ADDENDA #6
ITB NO. 1010-0-2021/LD
SDO BOARD ROOM, EXTERIOR FINISHES & ROOF PROJECTS
DATE: 12/6/21

A. The purpose of this addenda is to respond to Contractor questions:

1 FIRST FLOOR PLAN - NEW WORK

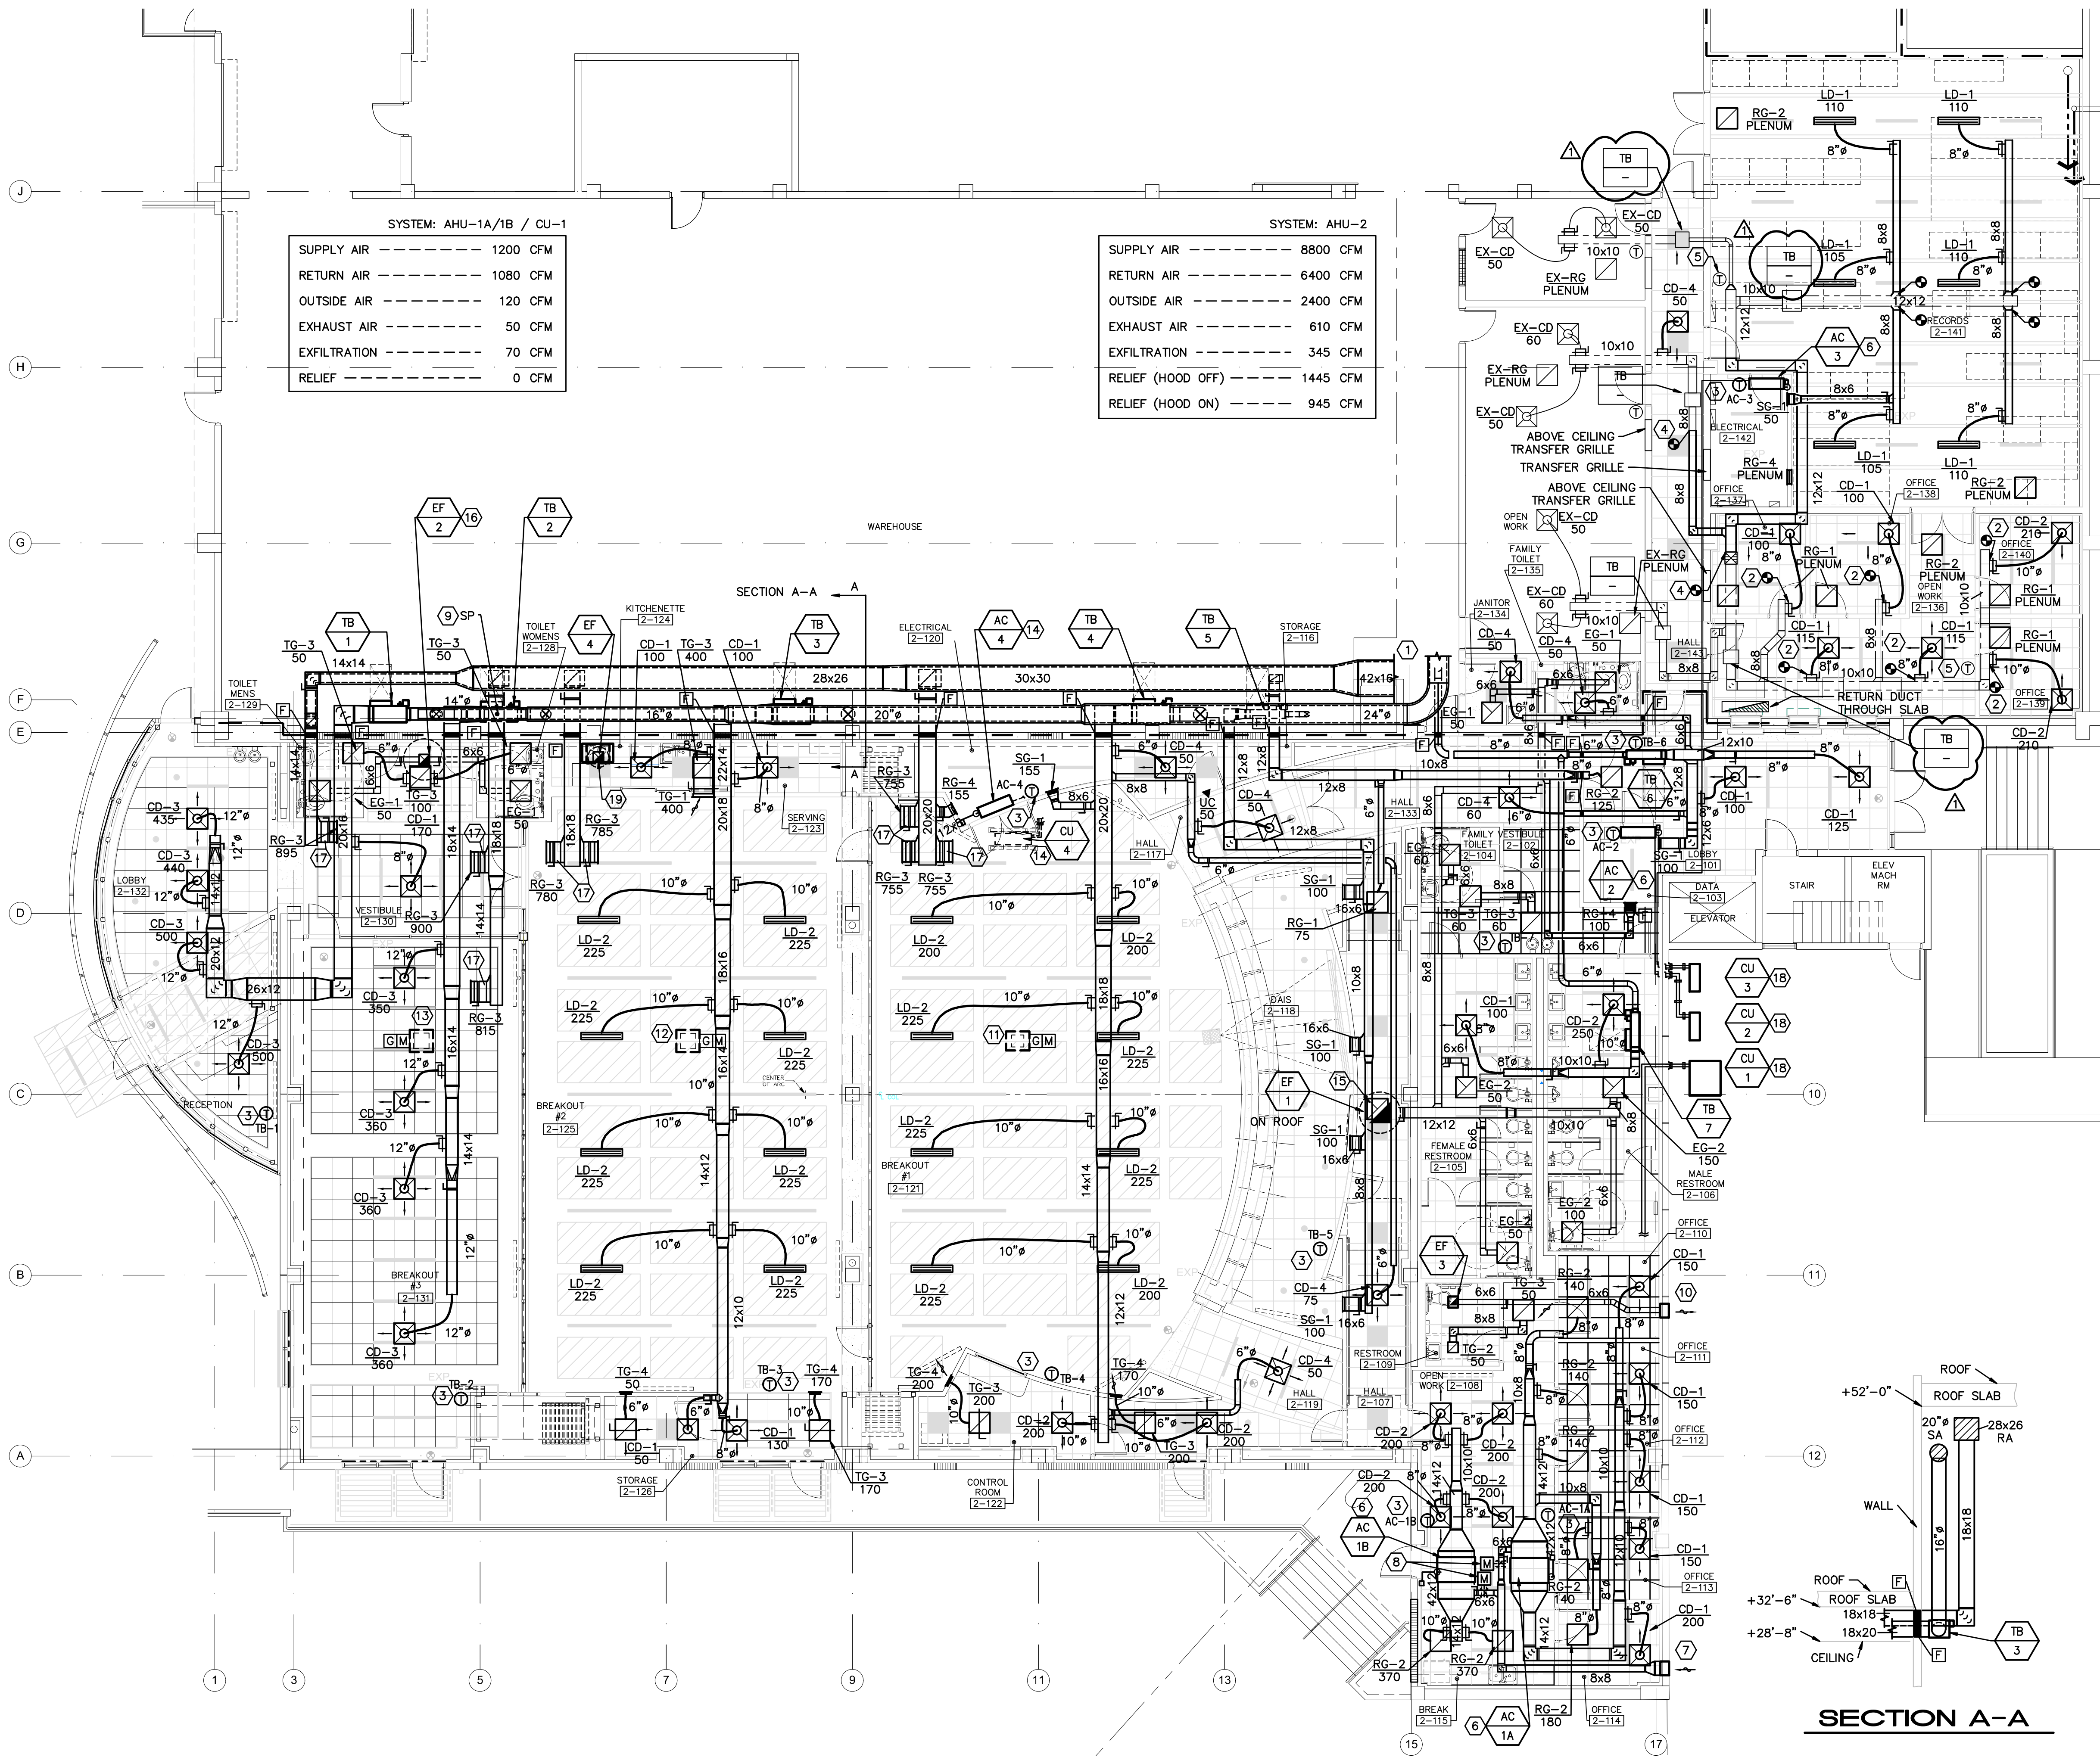
4. **Question:** HVAC Terminal Box Electrical Service: Sht. E-001, Terminal Box Schedule? Electrical Terminal Box Schedule shows units TB-1 through TB-7. HVAC plans also call for TB-8 and TB-9 which are not reflected in Electrical Schedule. Should TB-8 and TB-9 be added to the Electrical TB Schedule? Additionally, please note that Hall 2-143 (Sht. M-201, between TB-6 and TB-9) also shows a TB but without any TB designation/identification number which is also omitted from the Electrical TB Schedule? Additionally, please note that Hall 2-143 (Sht. M-201, between TB-6 and TB-9) also shows a TB but without any TB designation/identification number which is also omitted from the Electrical TB Schedule (separate RFI pertaining to the Mechanical sheet omission is to follow.

5. **Question:** HVAC Terminal Box electrical Service: Shts. M-003, M-201, E-001 and E-202, Terminal Box/Schedule?

A. Sht. M-003 “Variable Air Volume Terminal Box Schedule” ends at TB-7. However, plans identify a TB-8, a TB-9 and an unnumbered TB in Hall 2-143. Please address/clarify/correct as may be necessary.

E. M-201: Please complete data required for the unnumbered TB over Hall 2-143, next to TB-8.

Answer: **Terminal boxes shown that are in question are existing to remain As Is. Labeling has been removed to avoid confusion. See revised sheet M-201.**

- Answer:** **A. TB-8, TB-9 and unlabeled boxes are existing to remain As-Is labeling has been removed to avoid confusion. See revised sheet M-201.**
- B. Concur, sheets to be revised.**

- C. Concur; sheets to be revised.**
- D. Concur; sheets to be revised.**
- E. TB-8 is existing to remain As-Is. Labeling has been removed to avoid confusion. See revised sheet M-201.**

1 ELECTRICAL FLOOR PLAN - POWER
 E-202

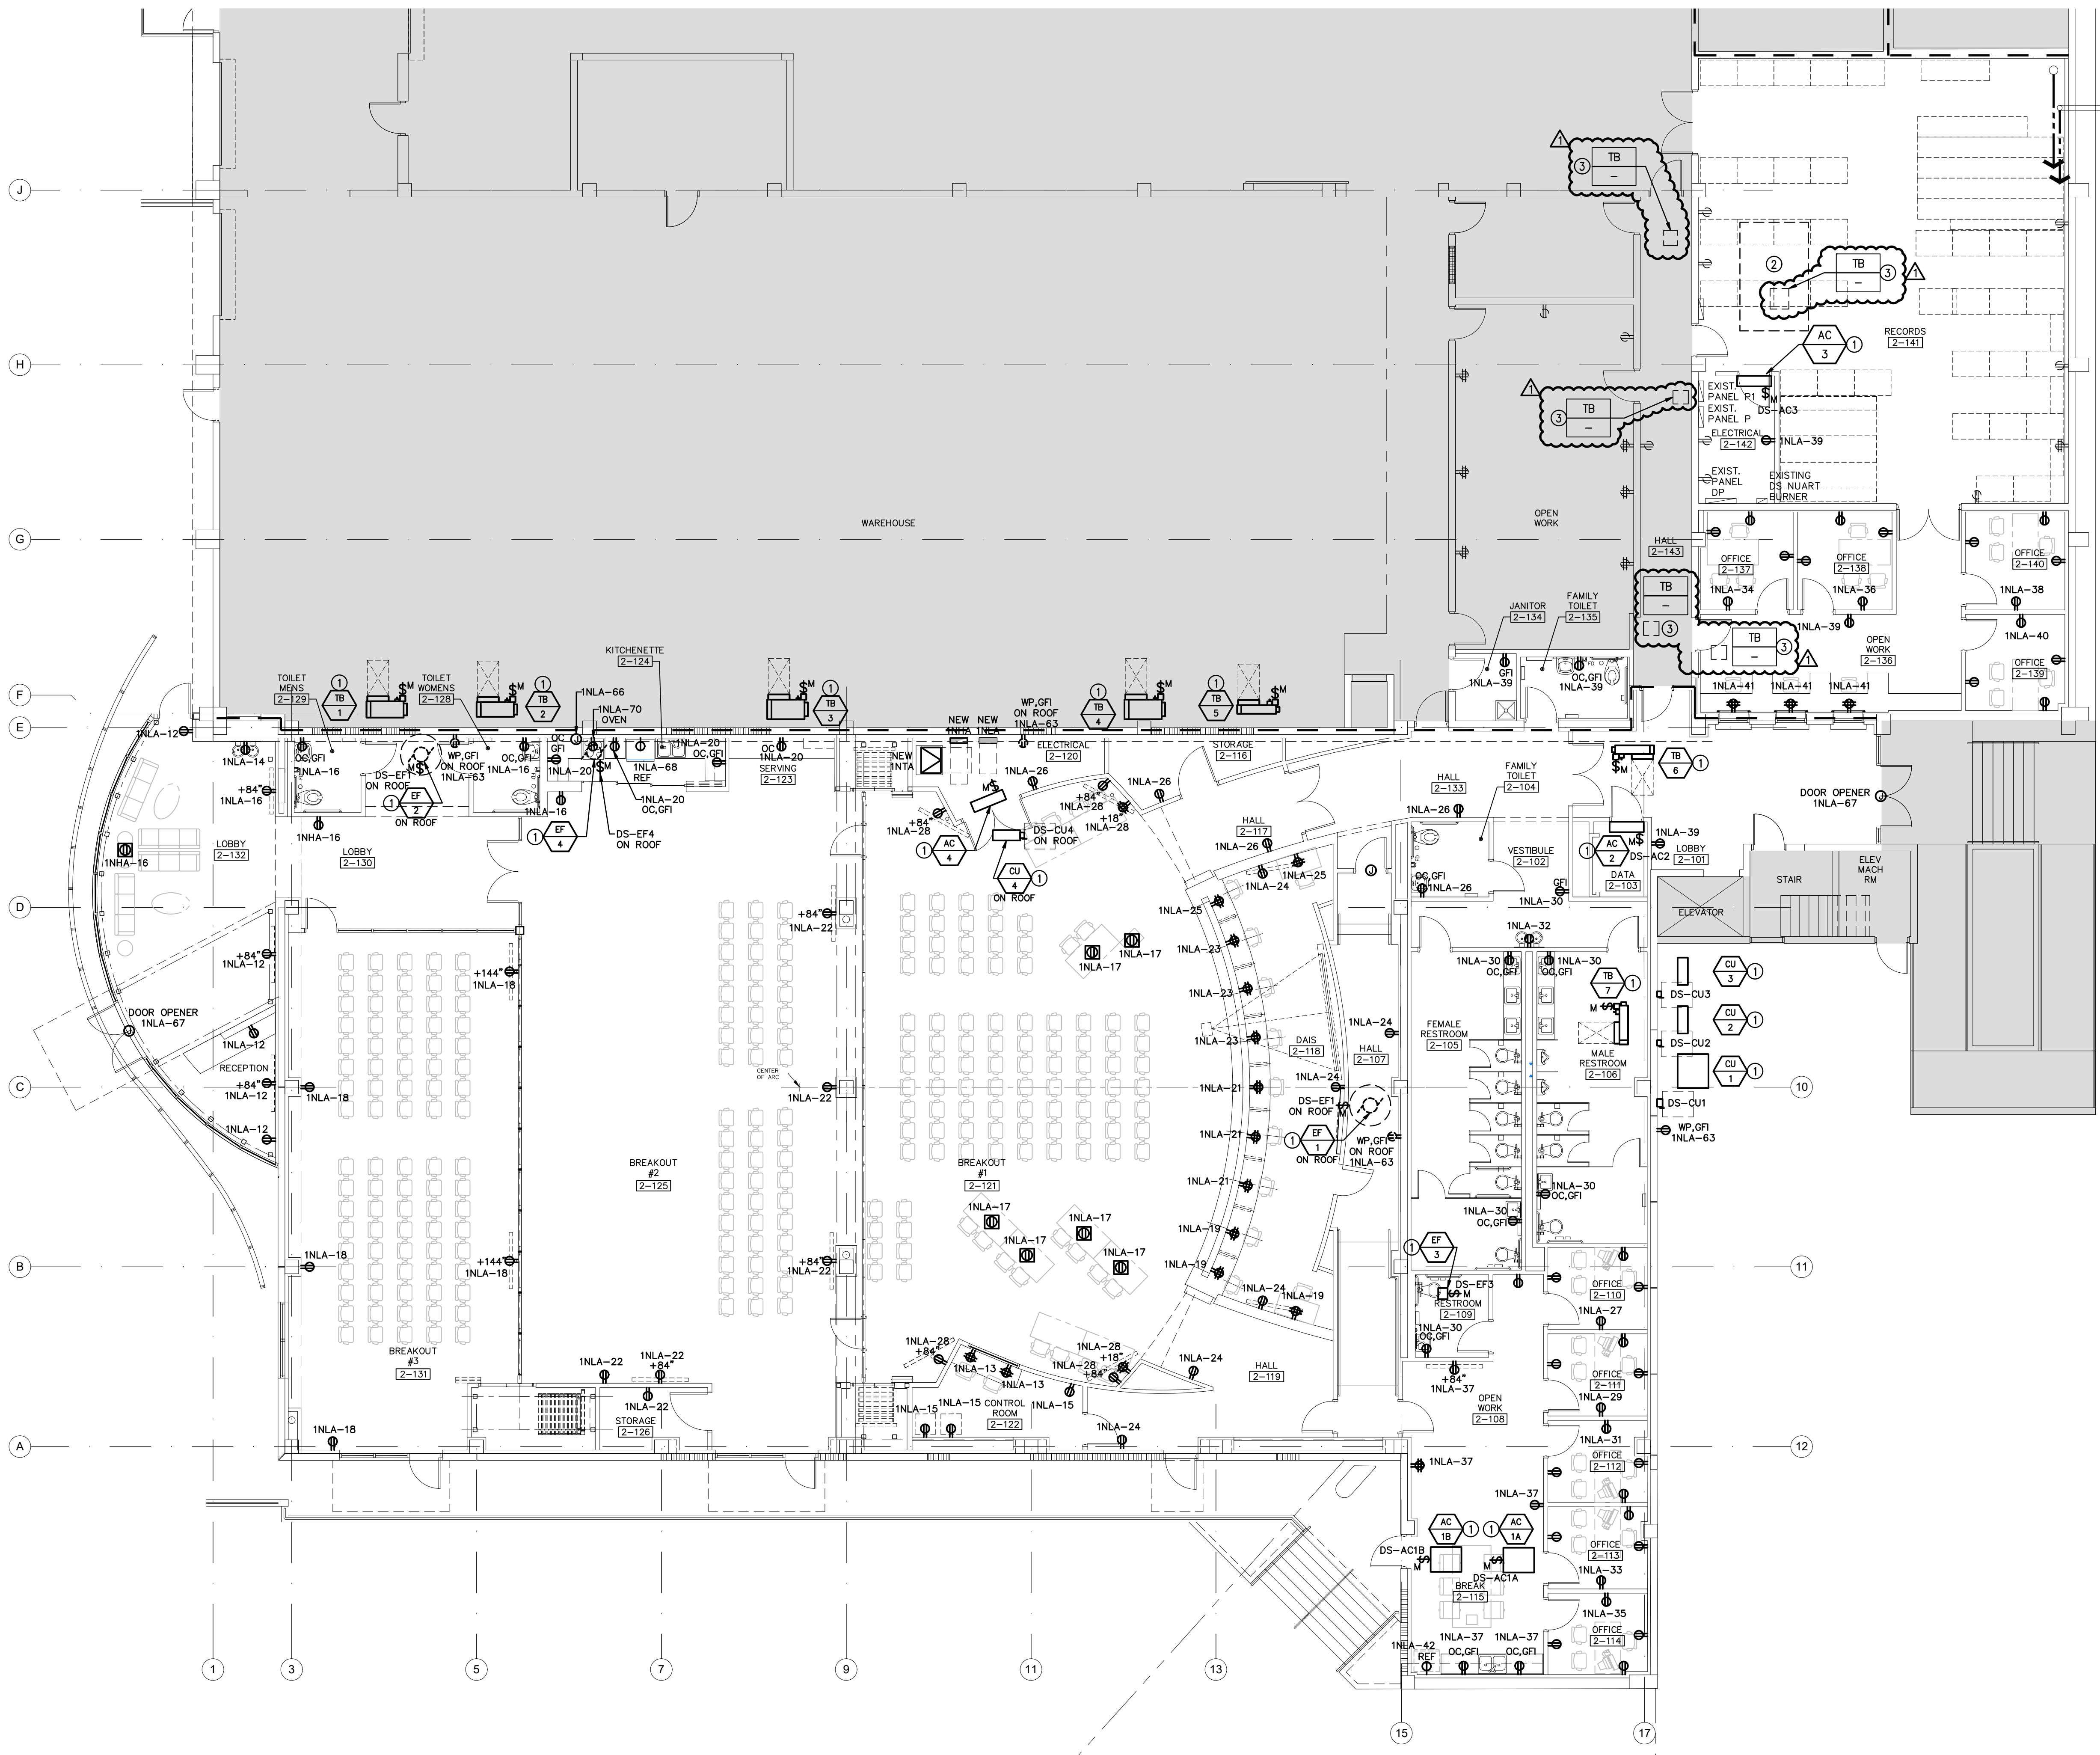
B. Sht. E-202 seems to be missing TB-8 at Rm. 2-136

C. Sht. E-202 seems to be missing the unnumbered TB in Hall 2-143 (between TB-6 and TB-9 as shown on M-201)

D. Sht. E-202 seems to be missing TB-9 at north end of Hall 2-143 as shown on M-201
